City of Portland, Oregon
Bureau of Development Services
Land Use Services
FROM CONCEPT TO CONSTRUCTION

NOTICE OF A TYPE II DECISION ON A PROPOSAL IN YOUR NEIGHBORHOOD

CASE FILE NUMBER: LU 14-248295 AD

Proposal: The applicant has proposed to expand and convert an existing detached outbuilding in the rear yard to an Accessory Dwelling Unit (ADU). The proposed structure is located behind (north of) the existing house, near the northwest corner of the lot, but out of the required 5'-0" rear setbacks. The structure is located 2'-8" from the west side lot line at the wall, with another few inches of eave extension beyond the wall. Regulations of the R5 zone require a minimum 5'-0" side building setback.

Exhibit C.1
 LU 14-248295
 AD

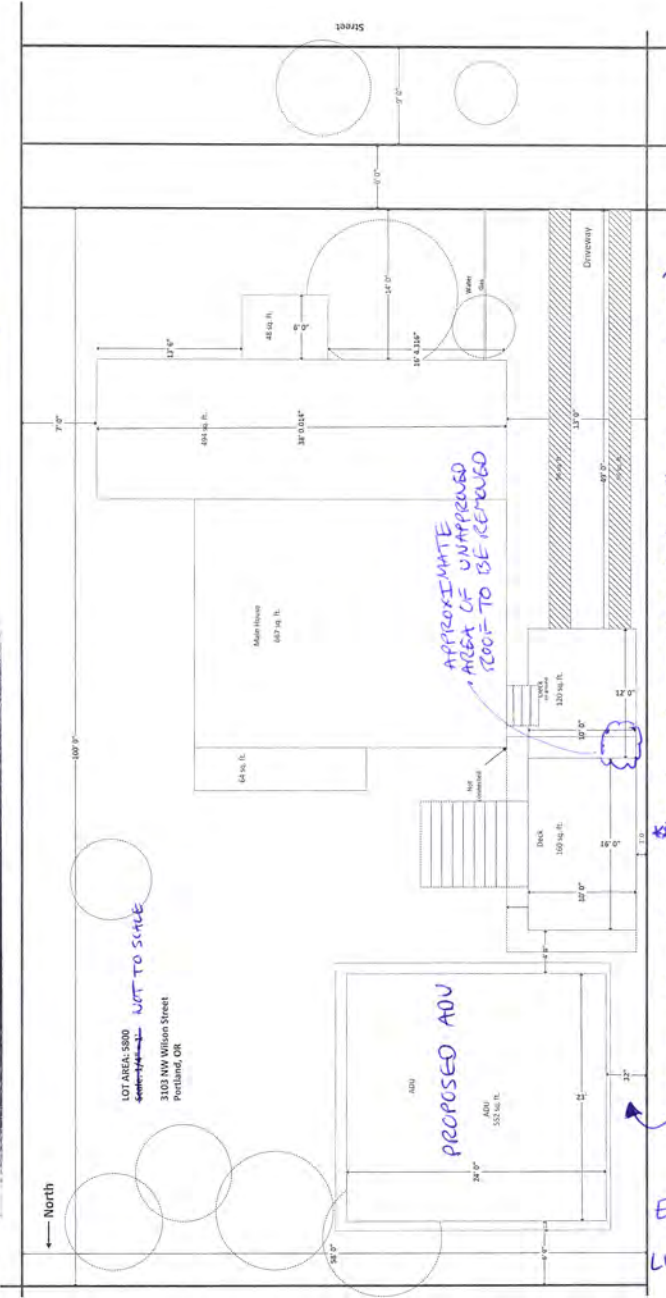
* APPROVE reduced west side setbacks and
 AOV roof pitch, trim, windows eaves; and
 DENT AOV siding Adjustment.

AREA OF CHANGE/REMOVED SETBACK (2'-8" TO WALL + EAVES)
 * PER REVISED/SECOND NOTICE ON 3/13/15

- B. The area of additional roof added to the existing covered deck at the southwest corner of the structure, within the west side setback (see Exhibits C.1, C.6 and G.5 for location), must be removed during the building permit process for the ADU, thereby restoring the covered deck to the size and footprint approved during LU 03-106734 AD.

W 14-248295 AD Exhibit C.5

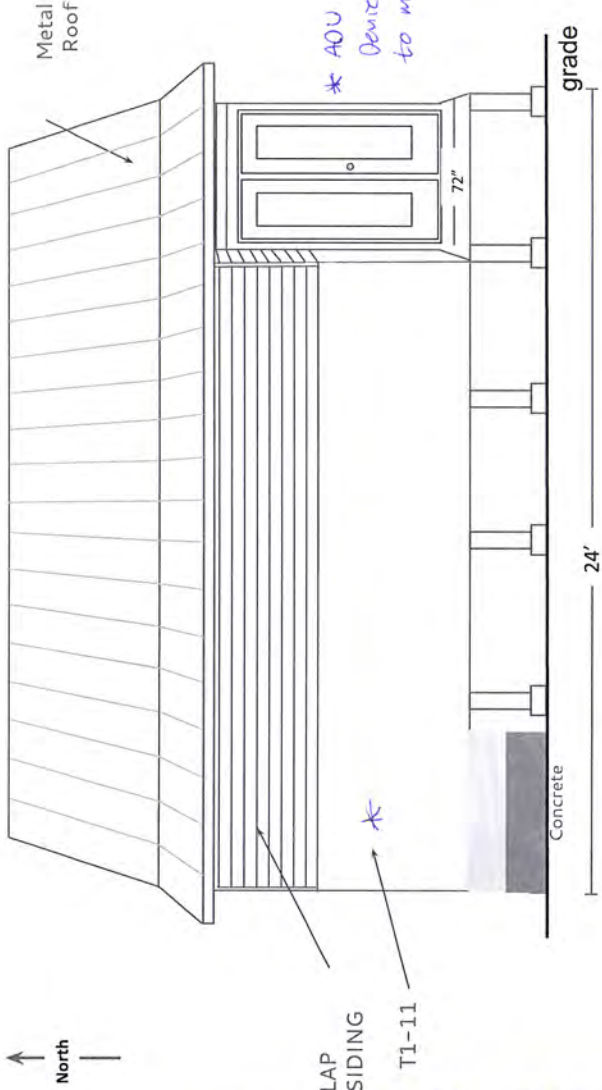
* ADU siding AD
Desired - siding
to match house.

Denial of an **Adjustment** to allow the ADU to have different siding than the existing house (33.205.030.C.7).

W14-248295 AD Exh. C-6

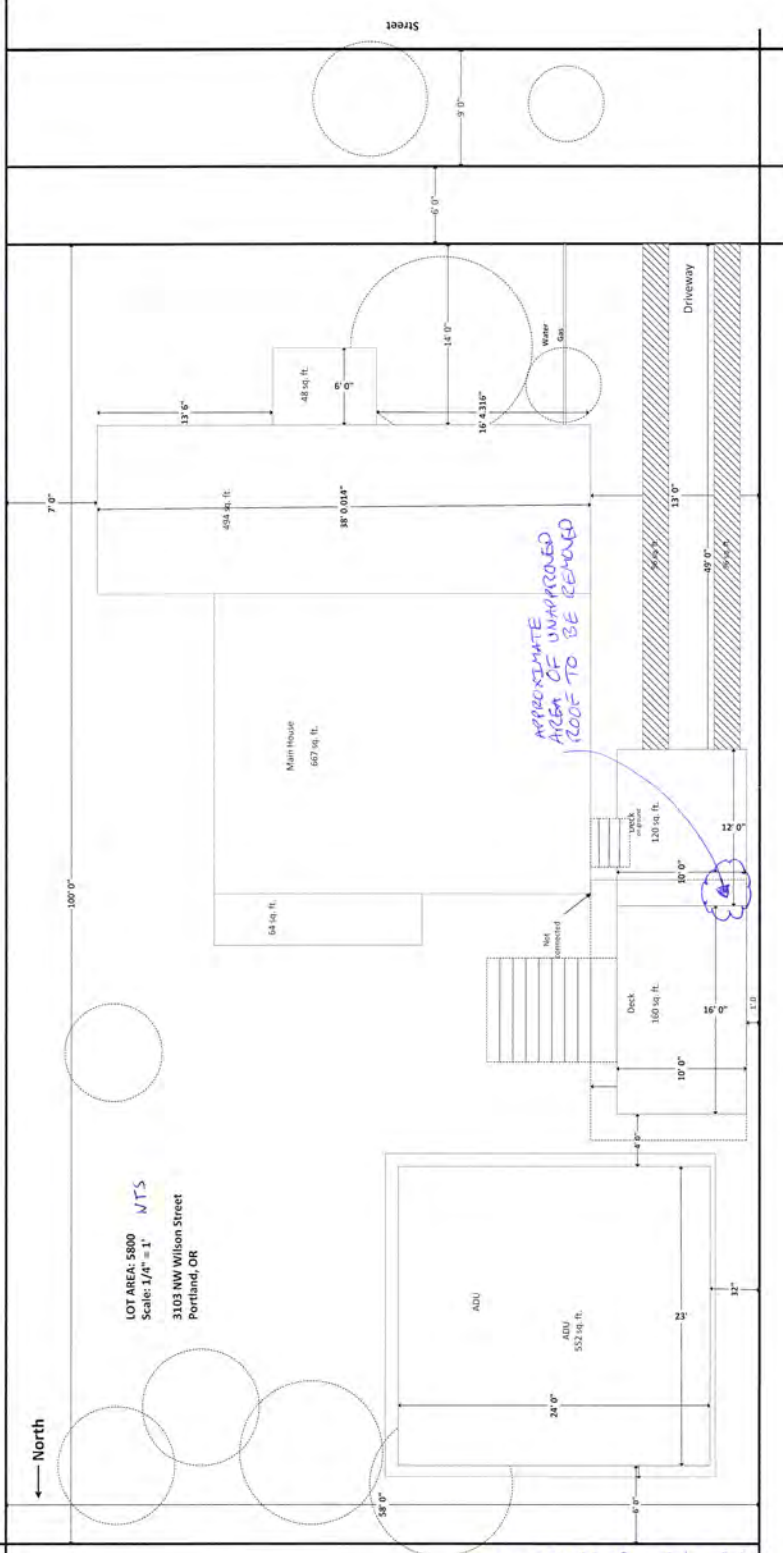
* ADU siding adjustment denied siding not match house
